Access Compliance Report

Public Rights-of-Way

(Curb Ramps)

Intersection ID: 7561	Main Street: LEMSFORD_WY	Cross Street: REMFORD_CT	Location: SE
ADA ID: F6A41F5C51FD	Ramp Type: Perp	Initial Pass/Fail: Fail	Overall Compliance: No
Severity Score: 12.5			
Codes/Mitigation Info/Possible Solution		Field Measurements/Component Compliance

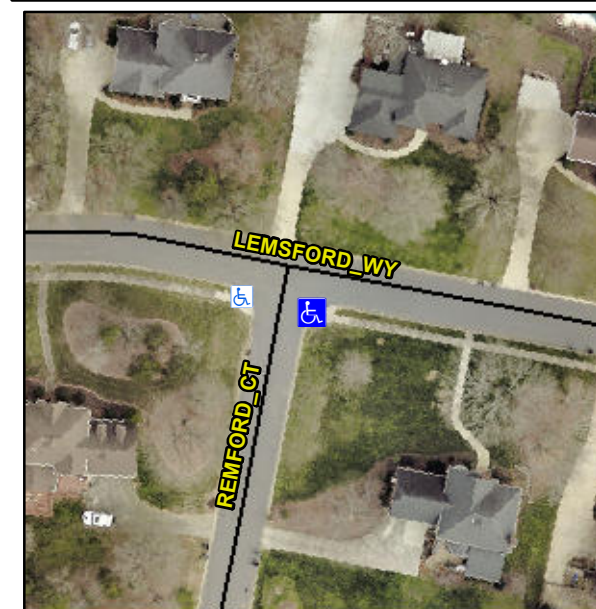
Not Found, R304.5.3

Compliance	Description	Data	Compliance	Description	Data
N/A	Ramp Length (in)	27.0	Yes	Ramp Slope (%)	5.0
Yes	Ramp Width (in)	48.0	No	Ramp XSlope (%)	6.0
N/A	Flare Type LT	N/A	N/A	Flare Type RT	N/A
N/A	Flare Slope LT (%)	N/A	N/A	Flare Slope RT (%)	N/A
N/A	Flare Traversable LT?	N/A	N/A	Flare Traversable RT?	N/A
N/A	Landing Length (in)	N/A	N/A	DWS Provided?	N/A
N/A	Landing Width (in)	N/A	N/A	DWS Contrast?	N/A
N/A	Landing Slope (%)	N/A	N/A	DWS Length (in)	N/A
N/A	Landing X Slope (%)	N/A	N/A	DWS Full Width?	N/A
N/A	Landing Curb? (Y/N)	N/A	N/A	DWS Offset (in)	N/A
N/A	Shared Landing?	N/A			
N/A	Gutter Ponding?	N/A	N/A	Gutter Slope (%)	N/A
N/A	Gutter Lip Ht (in)	N/A	N/A	Gutter X Slope (%)	N/A
N/A	Painted X Walk1?	No	N/A	Painted X Walk2?	N/A
	X Walk 1 Direction	To NW		X Walk 2 Direction	N/A
N/A	X Walk 1 Width (in)	N/A	N/A	X Walk 2 Width (in)	N/A
	X Walk 1 Slope (%)	3.0		X Walk 2 Slope (%)	N/A
	X Walk 1 X Slope (%)	5.7		X Walk 2 X Slope (%)	N/A

Remove & Replace Entire Ramp.
